LATEST REVISION DATE 04-12	 <b>Iowa Department of Transportation</b> Highway Division
	STANDARD DESIGN - 40' ROADWAY, THREE SPAN BRIDGE <b>PRETENSIONED PRESTRESSED CONCRETE BEAM BRIDGES</b> AUGUST, 2009
	<b>ABUTMENT BACKFILL DETAILS</b> A & B BEAMS - SKewed

**H40-93-06**

**SKewed ABUTMENT PLAN WITHOUT WING EXTENSIONS**  
(SKewed LEFT AHEAD SHOWN, SKewed RIGHT AHEAD SIMILAR)

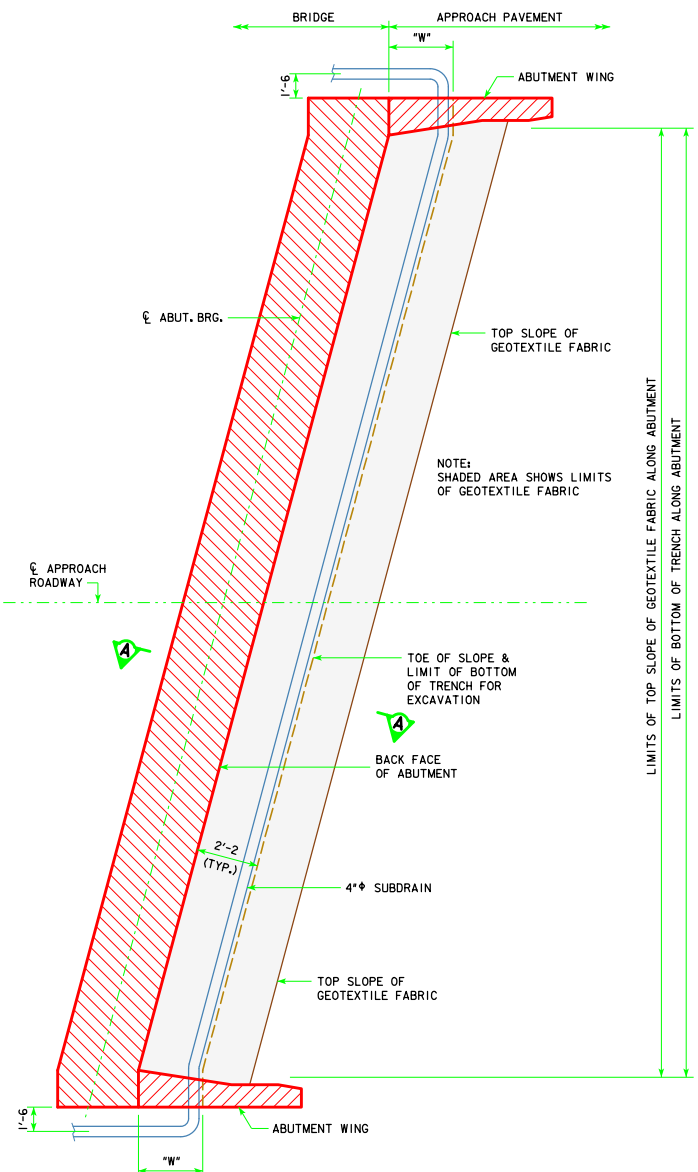
REVISED 04-12 - EXCAVATION LIMIT ON THE FRONT FACE OF THE ABUTMENT WAS CHANGED TO A 3'-0" LIMIT. THE APPROACH FILL WAS IDENTIFIED AS THE GRADING SURFACE.
